## Report to Development Permit Panel

**Re:** Application by Landcraft Homes Ltd. for a Development Permit at  
5751 Francis Road

**DP 17-768763 – ARTERIAL ROAD TRIPLEX**

**A-101**

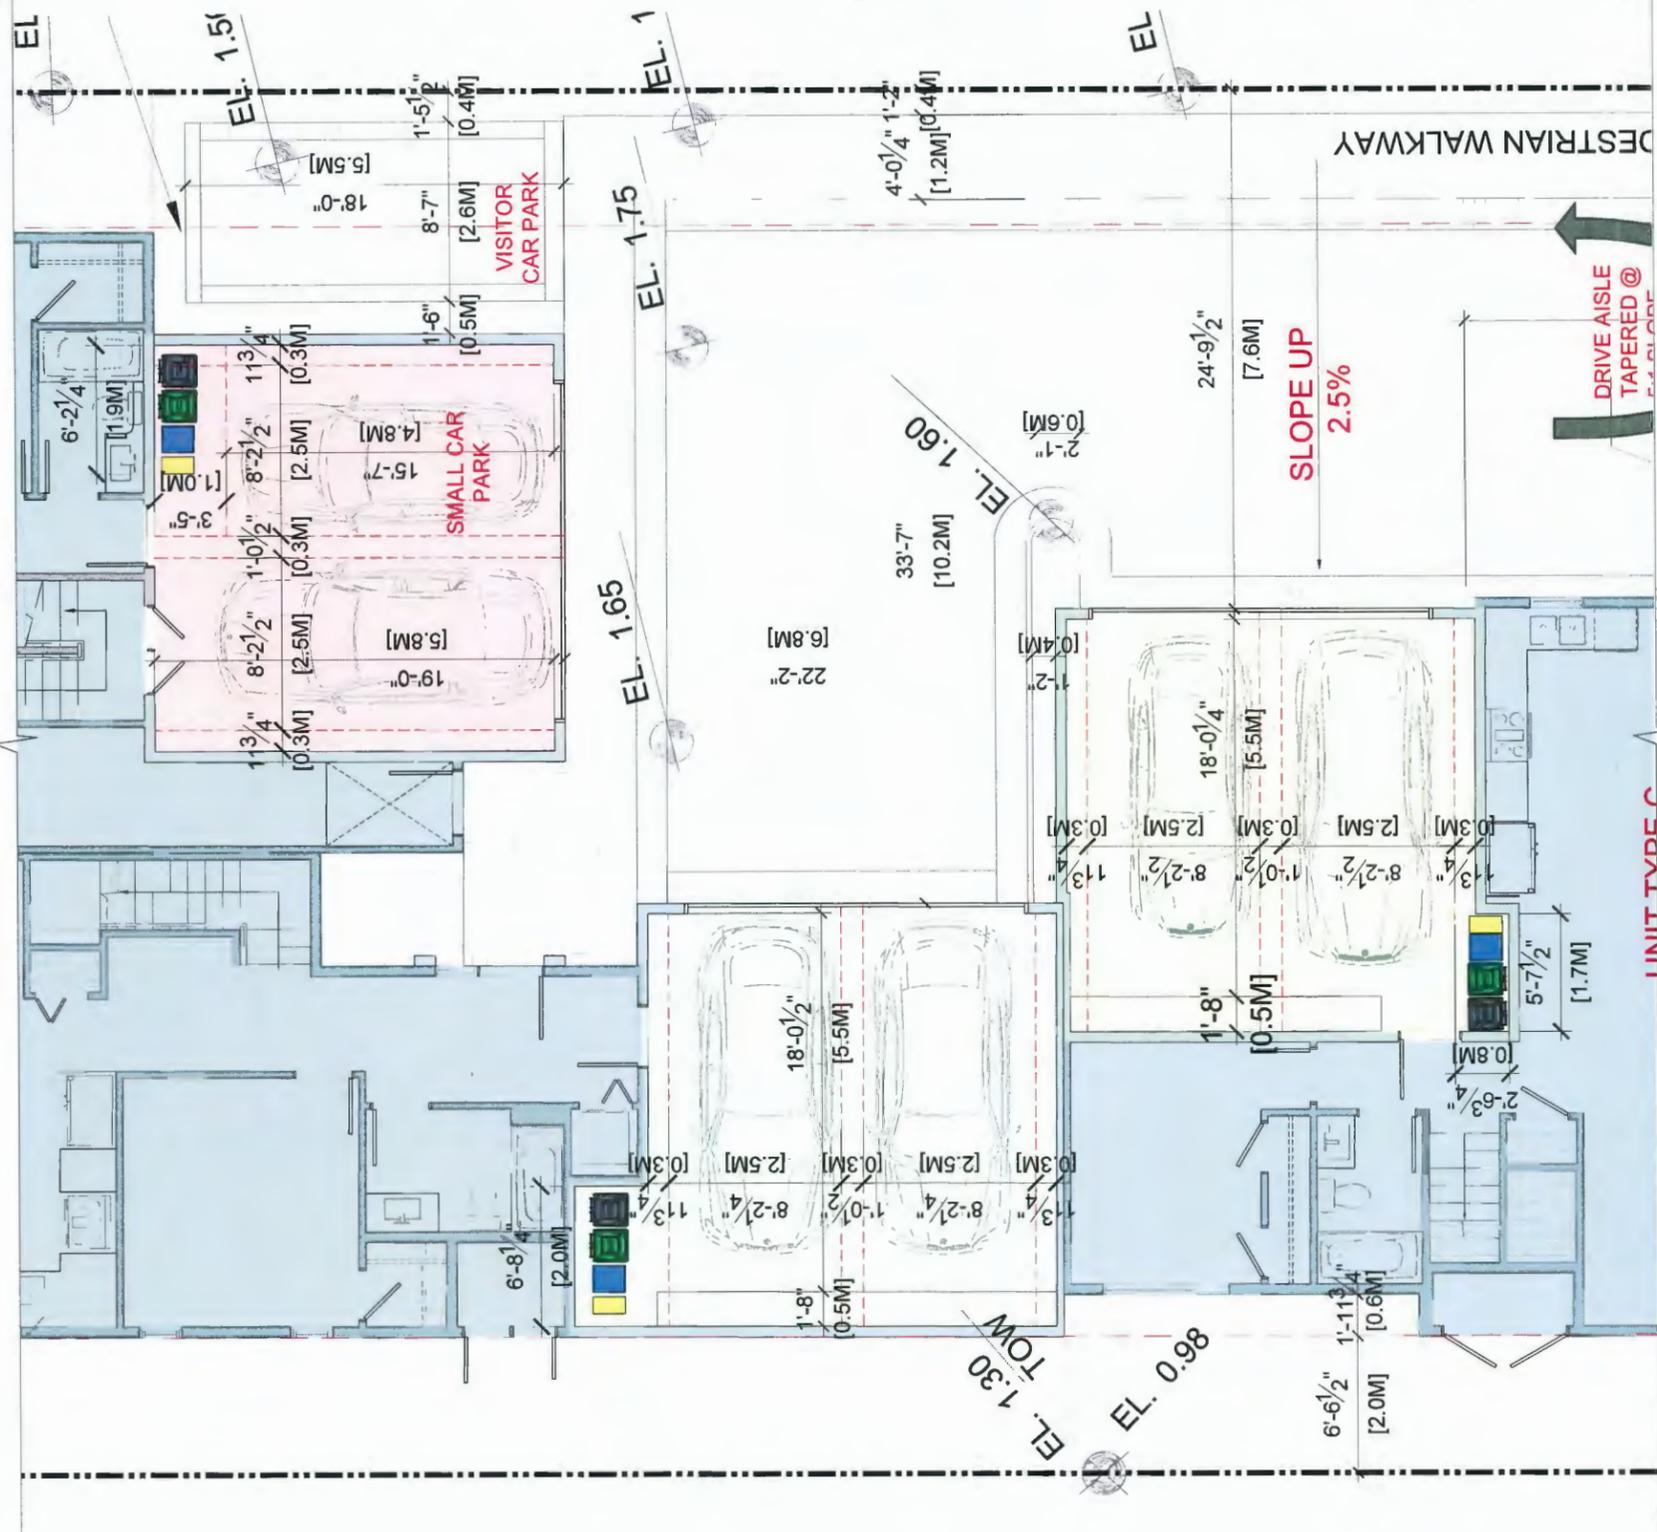
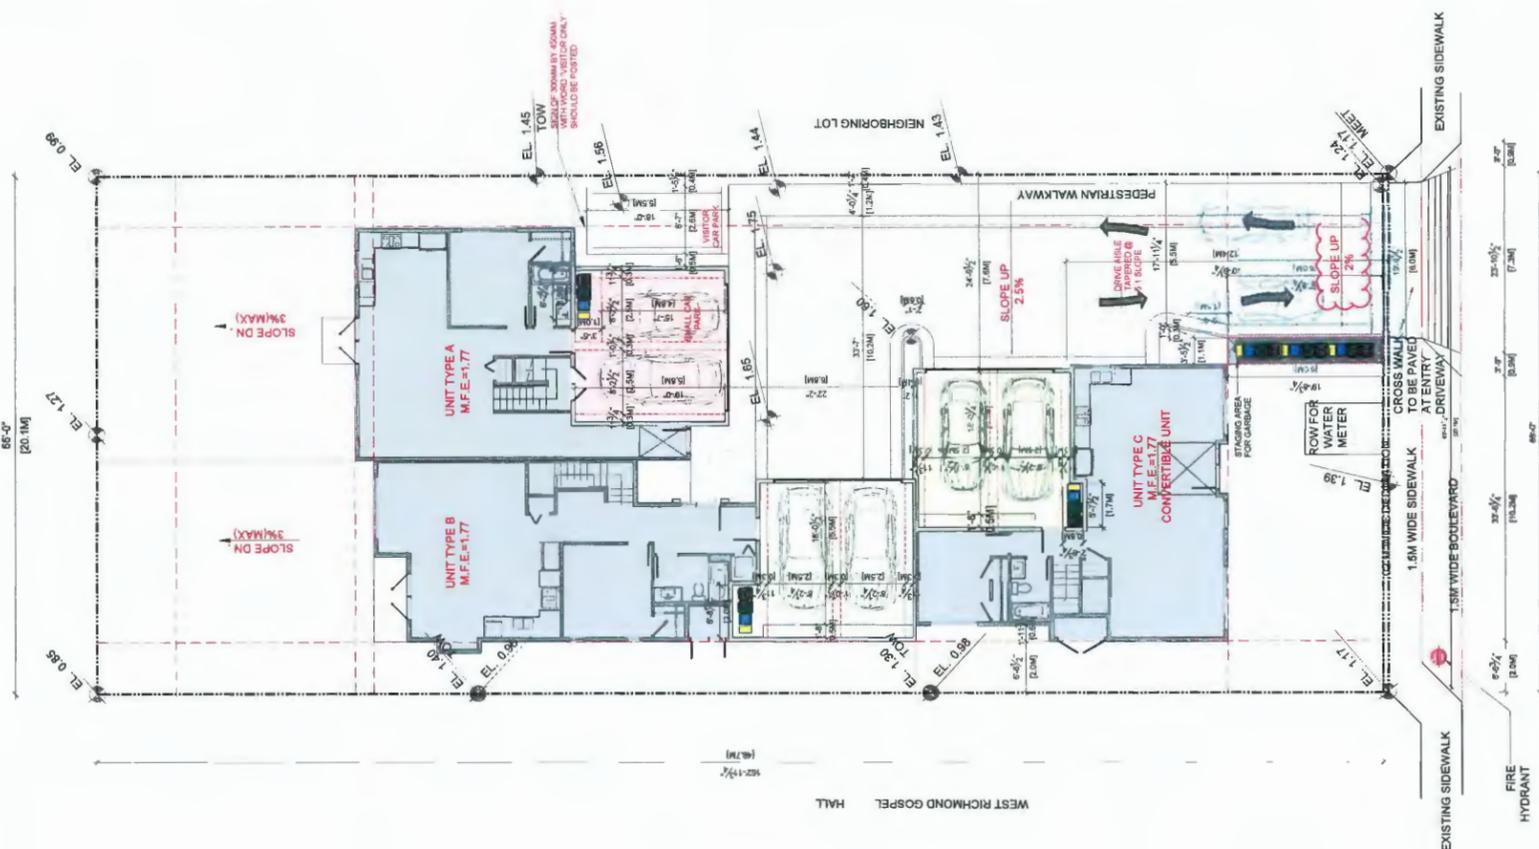
- ensure cross-slope of west and east accesses does not exceed 5% for accessibility and meter reading access;

***The cross slope of the west and east accesses is within 5%. Ref. sheet A-101.***

LIGHTING PLAN

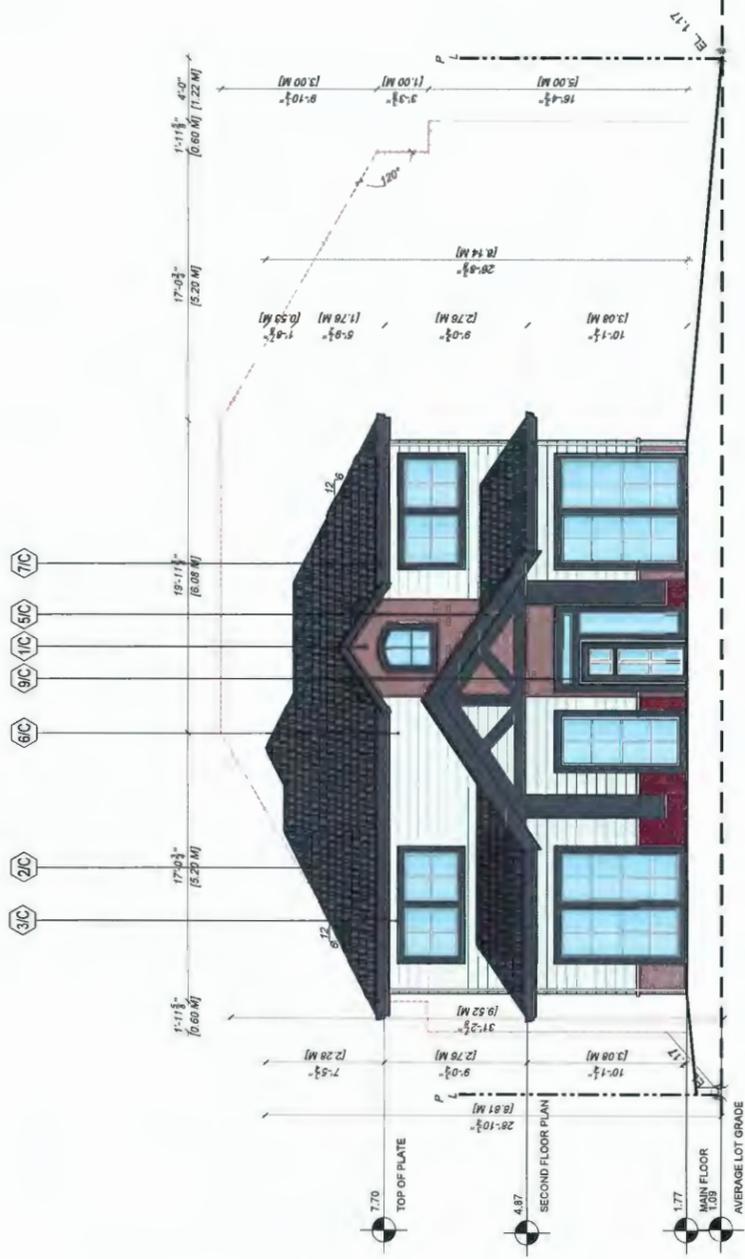
- there are too many down-reflected sconce lights on the exterior walls of the development; investigate opportunities for replacing some of these lights with bollard lights and emphasize lighting along the internal drive aisle as opposed to the perimeter of the triplex building;

***The lighting plan has been updated according. Ref. sheet A-504.***

1 SOUTH ELEVATION  
3/16" = 1'-0"

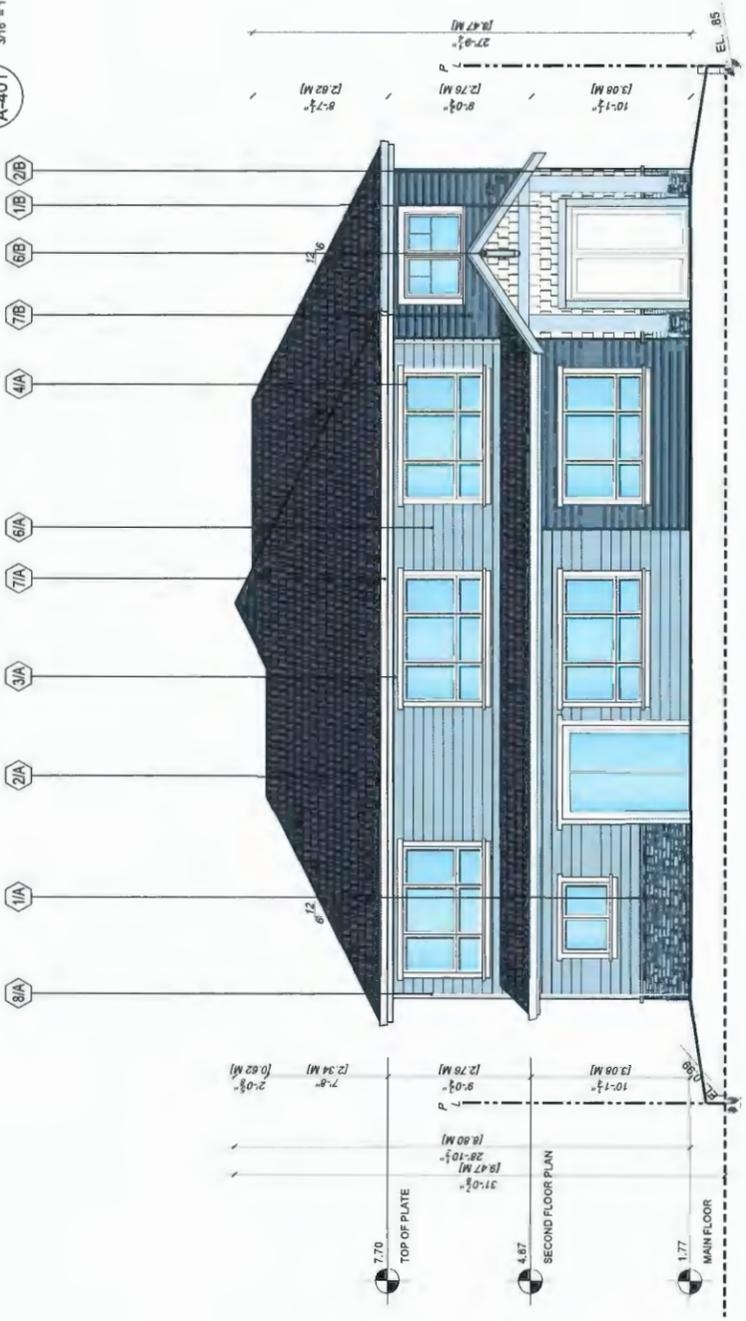
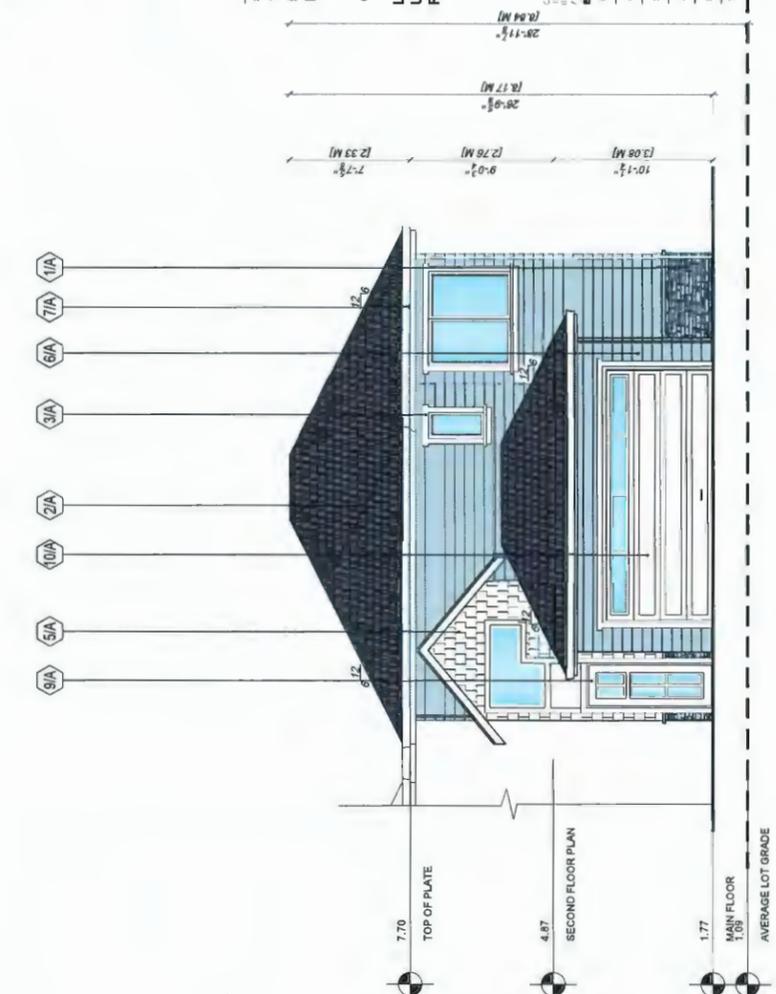
- review the design of the front façade of Unit C to better respond to the neighbourhood context;

- agree with the Panel comment that the materials and elevations of the northeast and northwest units (Unit A and Unit B) make sense but the front elevation of the unit facing the street (Unit C) does not tie in with the other building façades;

***The elevation of the front façade has been updated. Ref. sheet A-401.***

***The front elevation along Francis Road has been revised to better respond to the neighbourhood context. Ref. Sheet A-401.***
